Prairie Island Nuclear Generating Plant

February 21, 1997 Revision to
License Amendment Request Dated July 28, 1995

Proposed Changes Marked Up
On Existing Technical Specification Pages

Exhibit B consists of existing and new Technical Specification pages with the original proposed changes and all revisions highlighted on those pages. The existing and new pages affected by this License Amendment Request are listed below:

FIGURE TS.3.8-1 Spent Fuel Pool Unrestricted Region Burnup and Decay Time Requirements - OFA Fuel

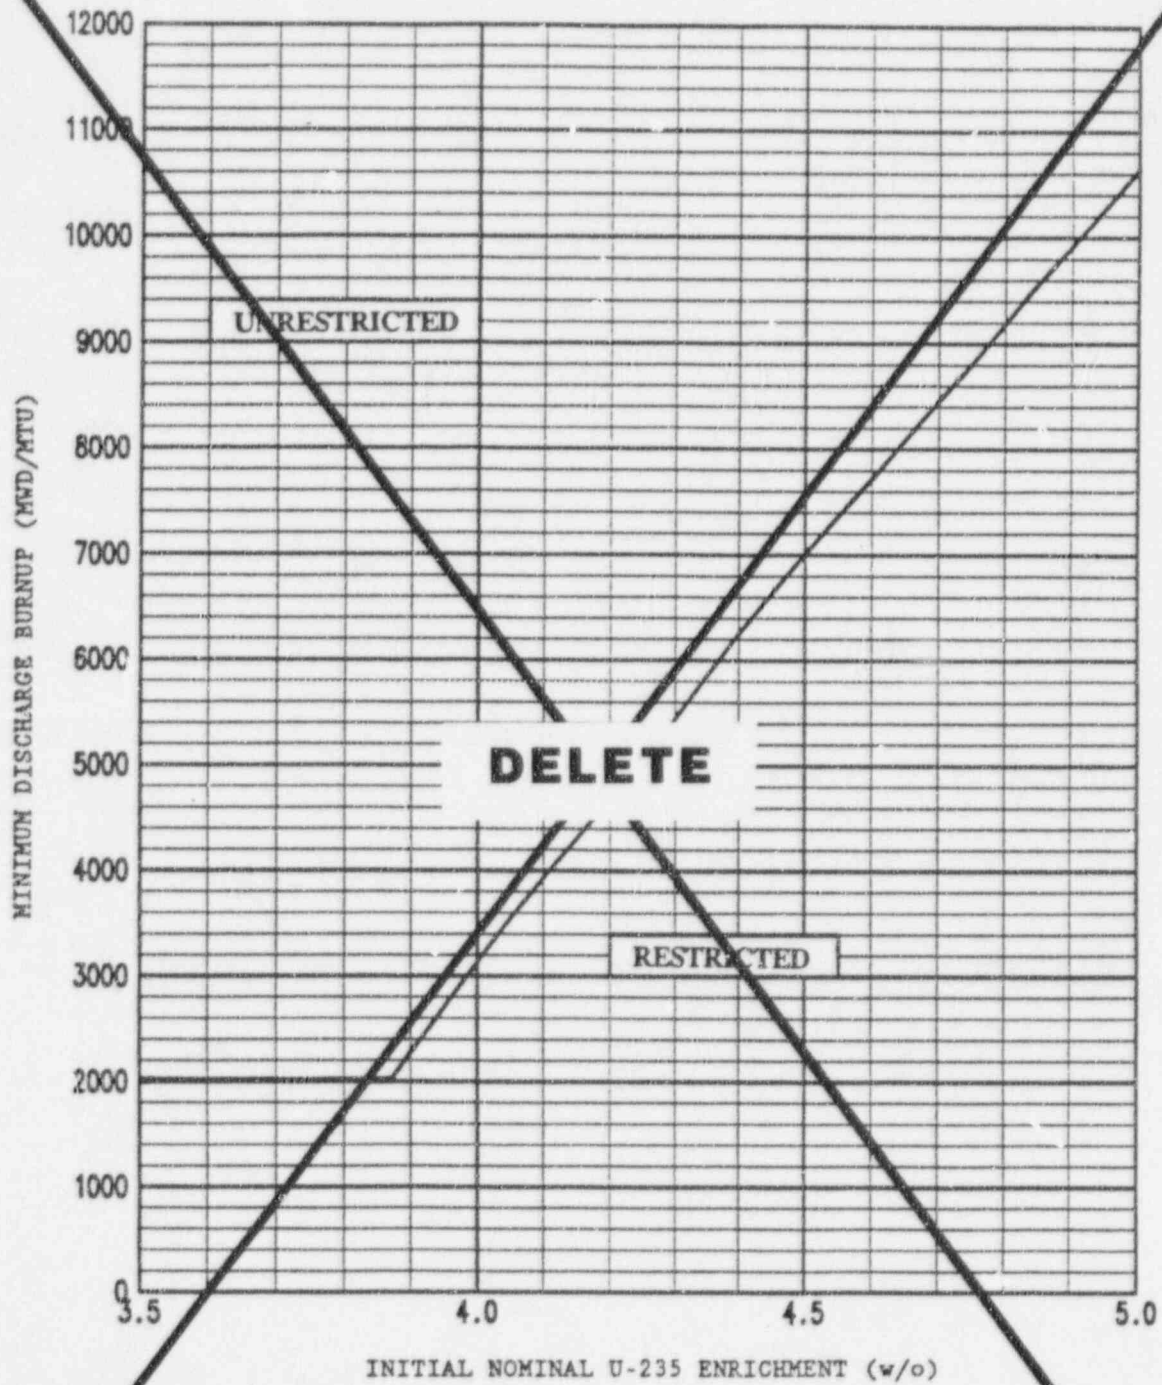
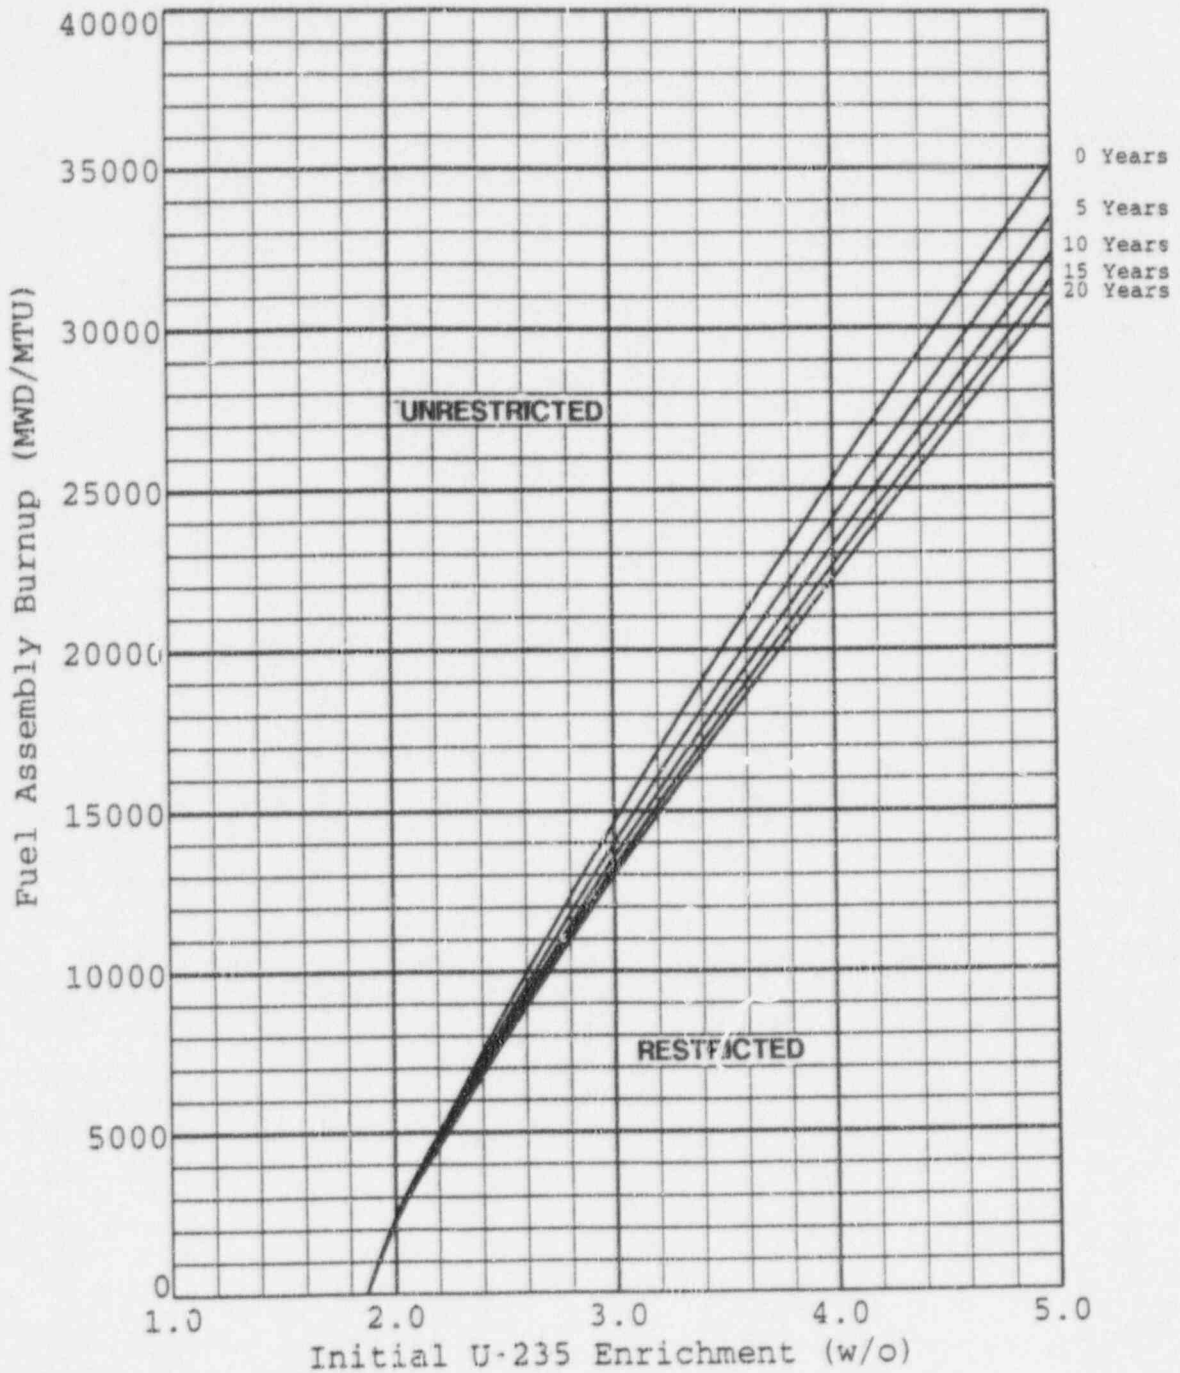
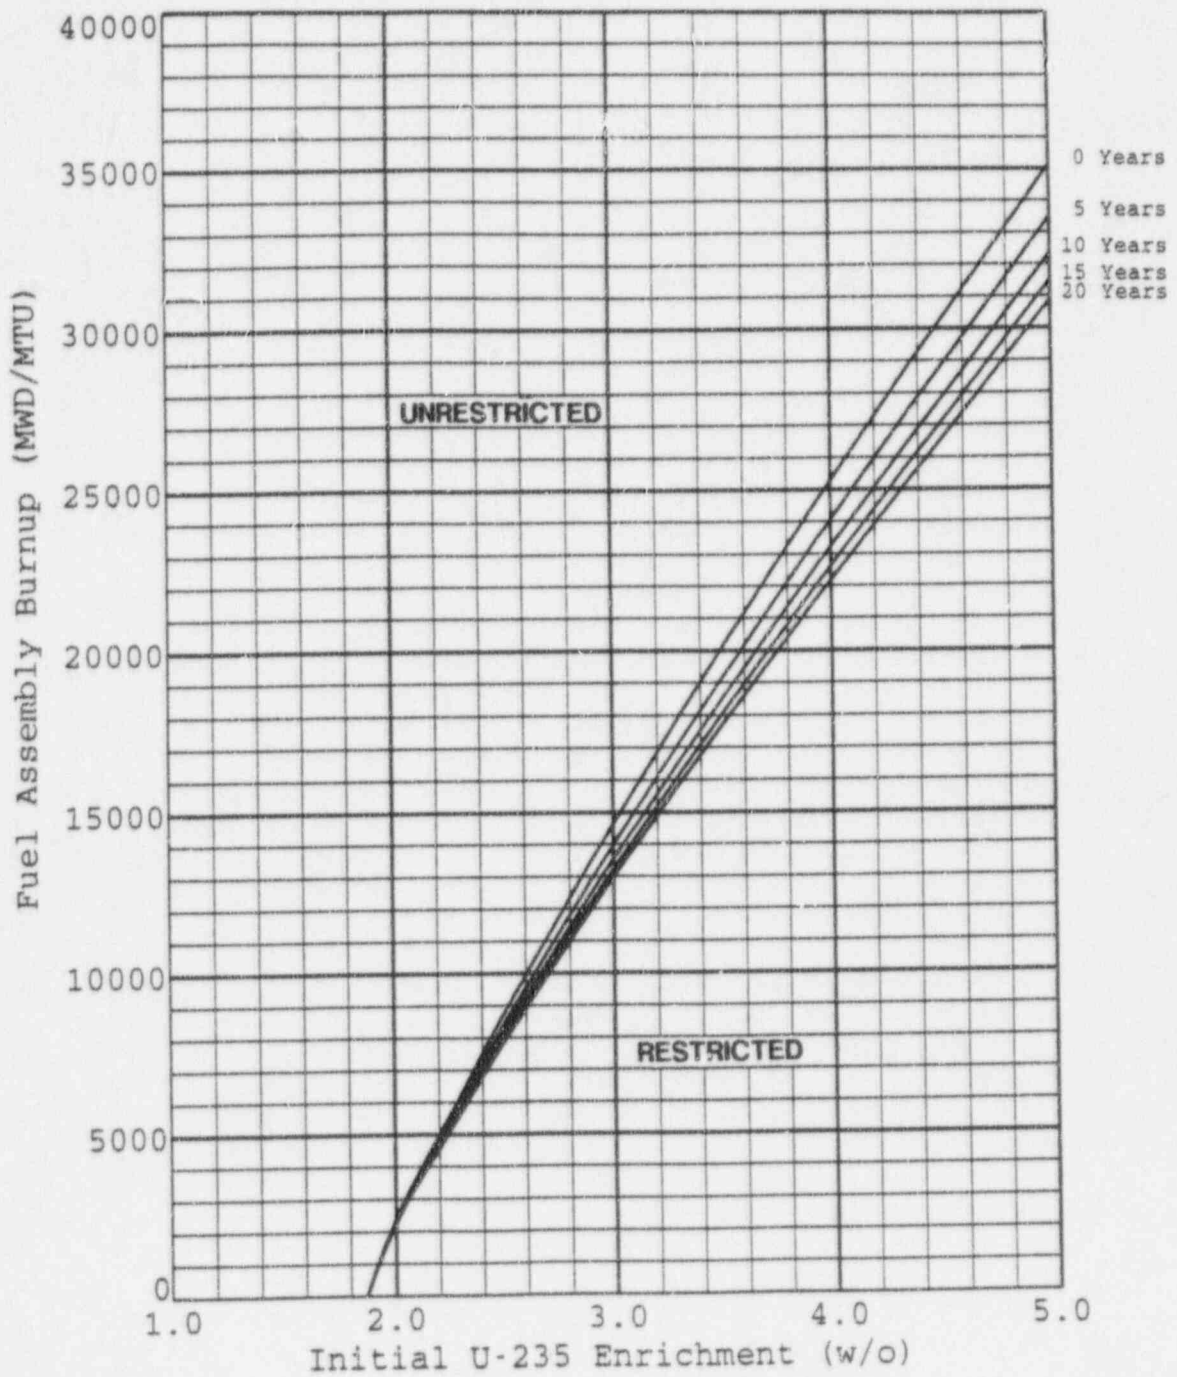
- a. ~~To be stored without restriction in the spent fuel pool, the burnup and initial enrichment of a fuel assembly shall be within the unrestricted range of Figure TS.3.8-1. The combination of initial enrichment, burnup and decay time of each spent fuel assembly stored in the spent fuel pool shall be within the unrestricted range of Figures TS.3.8-1 or TS.3.8-2, as applicable, or fuel assemblies shall be stored in accordance with Specification 5.6.A.1.e.~~
- b. ~~Fuel assemblies with a combination of burnup and initial enrichment in the restricted range of Figure TS.3.8-1 shall be stored in accordance with Specification 5.6.A.1.d.~~
- eb. If the requirements of 3.8.E.1.a and 3.8.E.1.b are not met, immediately initiate action to move any noncomplying fuel assembly to an acceptable location.
- ec. The provisions of Specification 3.0.C are not applicable.

- ed. New or spent fuel assemblies with a combination of discharge burnup, ~~and~~ initial enrichment and decay time in the unrestricted range of Figures TS.3.8-1 or TS.3.8-2, as applicable, may be allowed unrestricted storage in the spent fuel racks; and

Fuel assemblies that fall into the restricted range of Figures TS.3.8-1 or TS.3.8-2 are required to be stored in "fresh" cell locations as shown in Figure TS.5.6-1. The criteria included in Figures TS.3.8-1 and TS.3.8-2 for the selection of fuel assemblies to be stored in the "fresh" cell locations is based on a combination of fuel assembly type, initial enrichment, decay time and discharge burnup. ~~Fuel Assemblies stored in the "fresh" cell locations can have enrichments up to 5.0 wt% U-235 with no requirements for burnup or burnable absorbers.~~

- a. The combination of initial enrichment, burnup and decay time of each spent fuel assembly stored in the spent fuel pool shall be within the unrestricted range of Figures TS.3.8-1 or TS.3.8-2, as applicable, or fuel assemblies shall be stored in accordance with Specification 5.6.A.1.e.
- b. If the requirements of 3.8.E.1.a are not met, immediately initiate action to move any noncomplying fuel assembly to an acceptable location.
- c. The provisions of Specification 3.0.C are not applicable.

FIGURE TS.5.6-1 Spent Fuel Pool Burned/Fresh Checkerboard Cell Layout

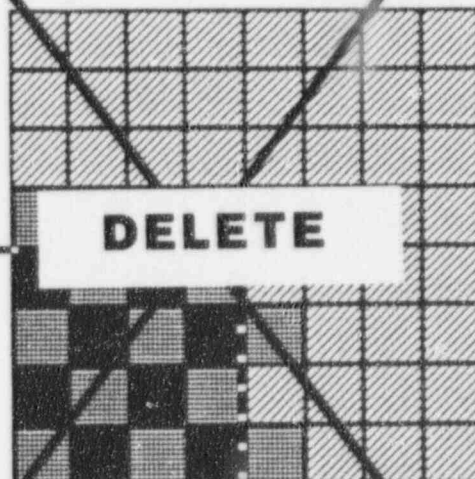
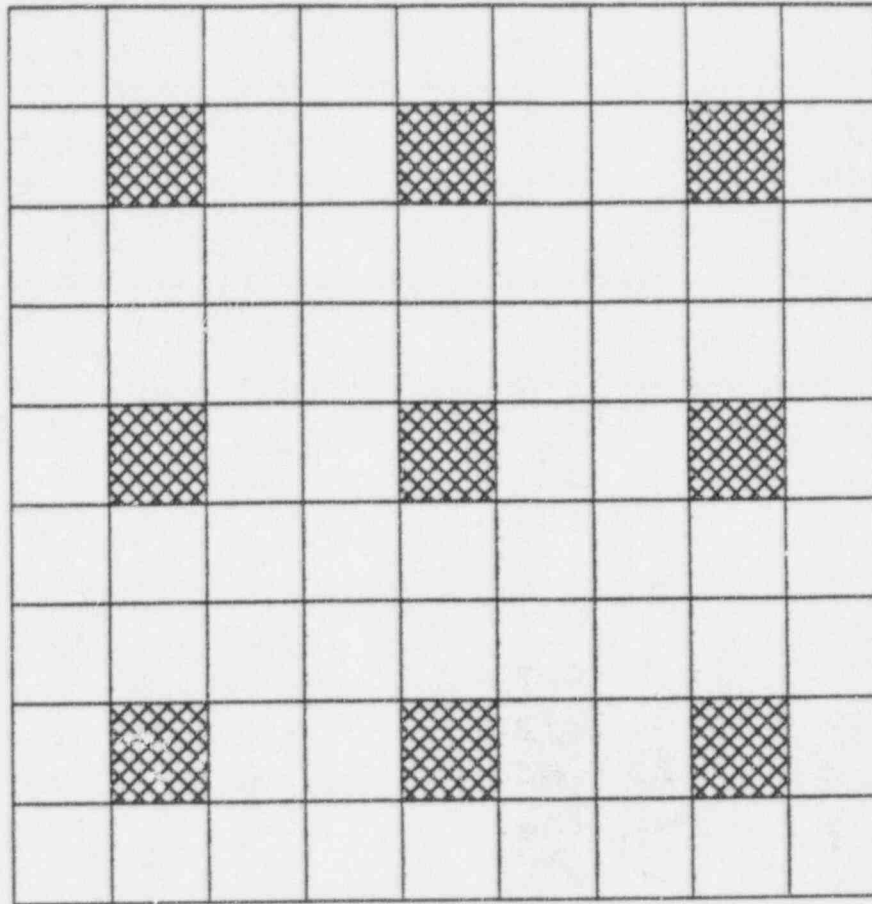
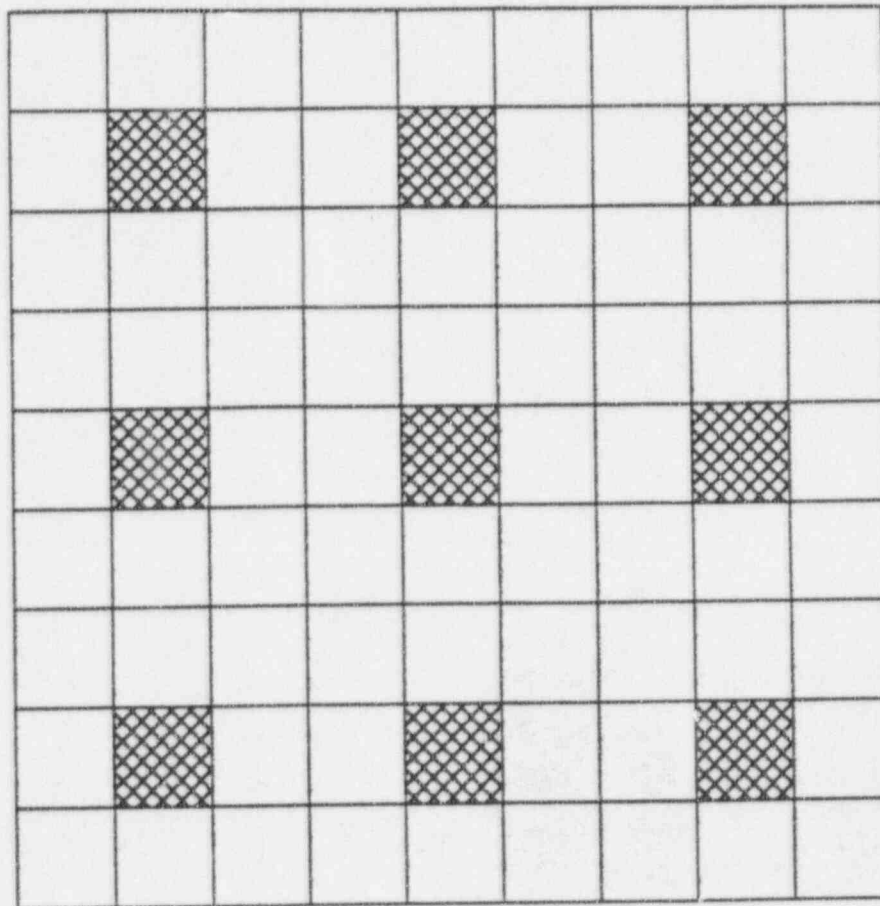
Burned Fuel: Must satisfy minimum burnup requirements
of Figures TS.5.6-3 through TS.5.6-12 depending
on number of GAD rods in fresh fuel

1. The first ~~region~~ storage configuration utilizes a checkerboard loading pattern to accommodate new or low burnup fuel with a maximum enrichment of 5.0 wt% U-235. This configuration stores "burned" and "fresh" fuel assemblies in a ~~2x23x3~~ checkerboard pattern as shown in Figure TS.5.6-1. Fuel assemblies stored in "burned" cell locations are selected based on a combination of fuel assembly type, initial enrichment, discharge burnup and decay time (Figures TS.5.6-3 through TS.5.6-12) ~~must have an initial enrichment less than 2.5 wt% U-235 (nominal) or satisfy a minimum burnup requirement.~~ The criteria for the fuel stored in the "burned" locations is also dependent on the number of rods containing Gadolinium in the center "fresh" fuel assembly. The use of empty cells is also an acceptable option for the "burned" cell locations. This will allow the storage of new or low burnup fuel assemblies in the outer rows of the spent fuel storage racks because the area outside the racks can be considered to be empty cells.

Burned Fuel: Must satisfy minimum burnup requirements
of Figures TS.5.6-3 through TS.5.6-12 depending
on number of GAD rods in fresh fuel
